**NC STATE UNIVERSITY**

20 November 2007

Re: Technical Specifications Amendment 17  
License No. R-120  
Docket No. 50-297

## RAI Number and Response

# VENTILATION AND RADIATION MONITORING SYSTEM DIAGRAM

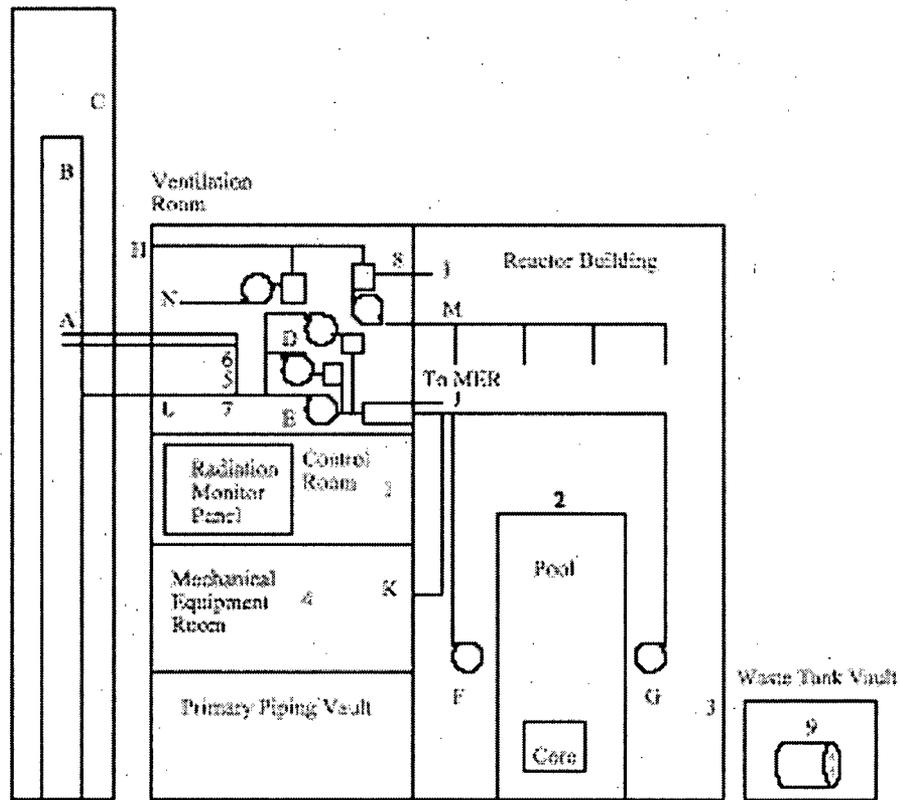
1. The ventilation exhaust flow rate with the new ventilation system is given as 1870 cfm.
  - a) Attachment B-1 shows a flow of 270 cfm into the exhaust plenum from an unidentified source. Is this source external to the reactor bay? If so, how are the fuel failure event durations, as calculated on page 49 of Appendix B, affected by the decreased reactor bay exhaust flow rate, and how does this affect off-site doses and AEC fractions? How are occupational accident doses affected by a longer reactor bay air exchange time?

- b) Attachment B-1 shows a flow of 200 cfm into the exhaust plenum from the BT&TC exhaust fan. Is this fan required to be running during accident scenarios? If not, how are the fuel failure event durations, as calculated on page 49 of Appendix B, affected by the decreased reactor bay exhaust flow rate, and how does this affect off-site doses and AEC fractions? How are occupational accident doses affected by a longer reactor bay air exchange time?

The ventilation system description provided in the amendment request was in error. Corrections are summarized below:

In the reactor building ventilation system, there is only one exhaust duct and only one exhaust fan in operation at a given time. For normal ventilation, the nominal fixed exhaust rate is 1870 cfm. In confinement mode, the nominal fixed exhaust rate is 600 cfm. The (Pneumatic) PN and (Beam Tube & Thermal Column) BT&TC fans are used to move air these systems or areas into the exhaust duct without entering the reactor bay. The PN and BT&TC fans do not increase the ventilation system exhaust rate. 270 cfm is the air return flow rate from the ventilation room.

The 270 cfm is the air return flow rate from the ventilation. This air flow has no effect on the fuel failure event duration, off-site doses, or AEC fractions calculated in Attachment 2. Attachment 2 used exhaust flow rates of 1870 cfm for normal ventilation and 600 cfm for confinement.

The 200 cfm is the input into the normal ventilation from the BT & TC if it is on. This fan is routinely used while the reactor is in operation and turned off upon reactor shutdown or initiation of confinement. If an accident occurs, this fan would have no effect on the accident analyses. Calculations given in Attachment 2 were performed at a normal ventilation exhaust rate of 1870 cfm and confinement exhaust rate of 600 cfm. Therefore, the calculations are not affected.

Figure 2.1-1: Power-Flow Safety Limit Curve

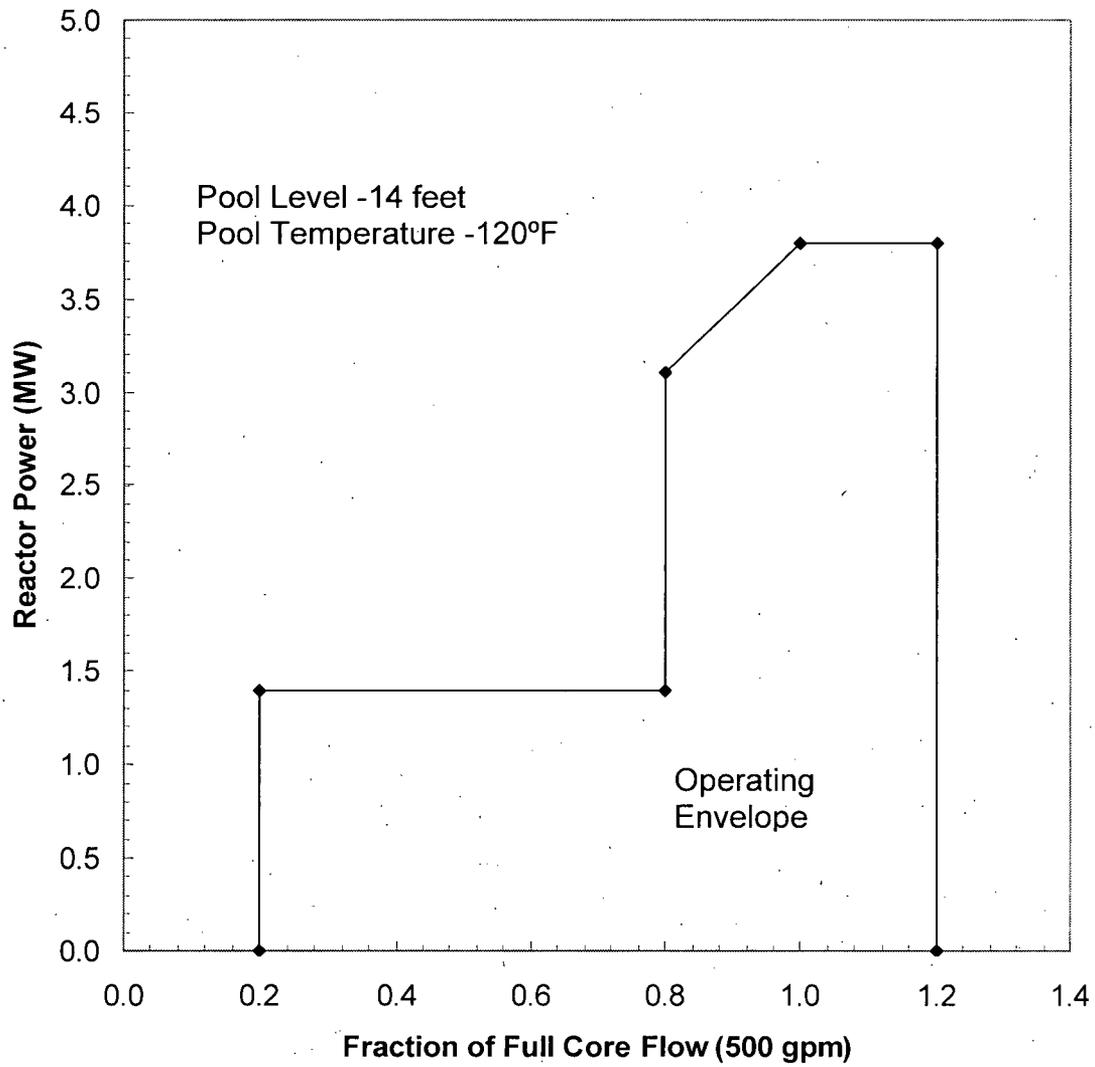
8. Figure 2.2-1, Power-Flow Safety Limit Curve

In the proposed TS this figure does not show the Operating Envelope as the same figure did in the previous version of TS. Also, in the proposed version of the figure the labeling does not specify the Safety Limit Specifications that the pool level shall be 14 feet or greater and the pool temperature shall not be greater than 120 °F. Since Specification 2.2.1.a. references the operating envelop in the figure the fact that it is missing may cause confusion. In addition, the title for the figure contains a typo with the word "full" rather than "flow." Please clarify your intentions with regard to the labeling on this figure.

This comment applies to Figure 2.1-1. The changes noted in this statement have been made to Figure 2.1-1 in the revised Technical Specification amendment.

**Figure 6.1-1: NCSU PULSTAR Reactor Organizational Chart**

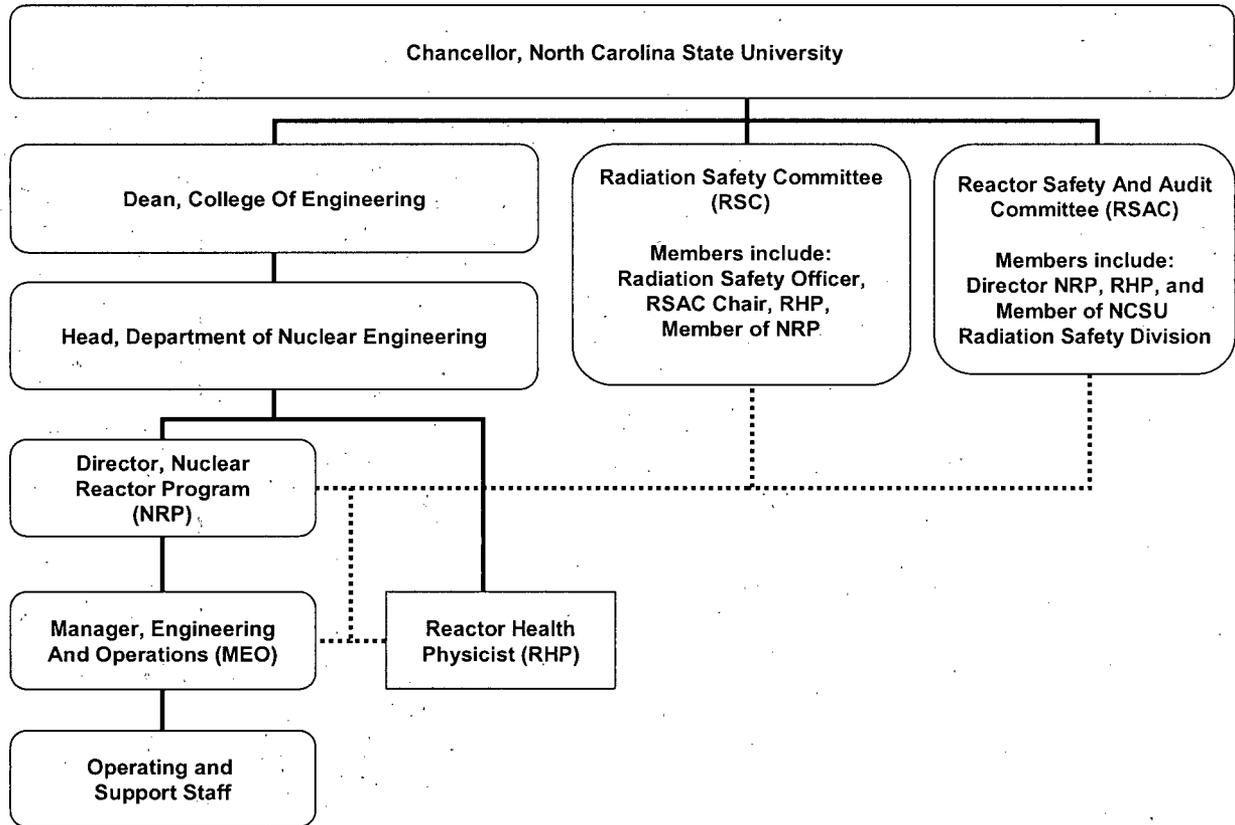
The advice and liaison lines have been removed with the proposed Figure 6.1-1. Provide discussion of the changes in the organizational structure. Include changes in responsibility, authority, and lines of communications, e.g. what are the interface inter relationships between the Reactor Health Physicist, the Nuclear reactor Program personnel, the Reactor Safety Committee, and the Reactor Safety and Audit Committee. Discuss the change from the Reactor Safety Committee reporting to the Reactor Safety and Audit Committee which in turn reports to the Chancellor and the proposed structure where they both report to the Chancellor independently. Discuss how the proposed changes will affect safety, independence, and oversight.

One change to Figure 6.1-1 is that it now shows the RSAC no longer reports to the RSC. This is reinforced by the removal of the statement that the RSC performs final review of the actions of the RSAC. Discuss the reason for that change and the safety implication.

Advice and liaison lines in Figure 6.1-1 have been added. The notes for Figure 6.1-1 have been changed to indicate direct communication and advice and liaison as follows:

Also, RSC and RSAC membership by positions knowledgeable of reactor operations and radiation safety have been added to Figure 6.1-1.

- RSC receives the audit report information from the RSAC.
- In the proposed TS, RSAC informs RSC of its actions and RSC and RSAC are allowed to communicate directly with each other. Furthermore, RSC may require additional actions by the RSAC or NRP. RSAC, RSC, and the RHP continue to be independent of the NRP as shown in Figure 6.1-1.
